Addendum 13 – UN Regulation No. 14

Revision 6 - Amendment 1

09 series of amendments – Date of entry into force: 29 December 2018

Uniform provisions concerning the approval of vehicles with regard to safety-belt anchorages

Model A

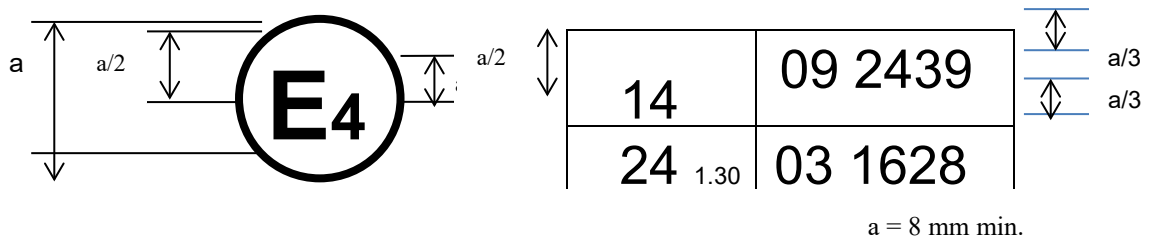
Annex 2, amend to read:

The above approval mark affixed to a vehicle shows that the vehicle type concerned has, with regard to safety-belt anchorages, been approved in the Netherlands (E 4), pursuant to UN Regulation No. 14, under the number 092439. The first two digits of the approval number indicate that UN Regulation No. 14 already included the 09 series of amendments when the approval was given.
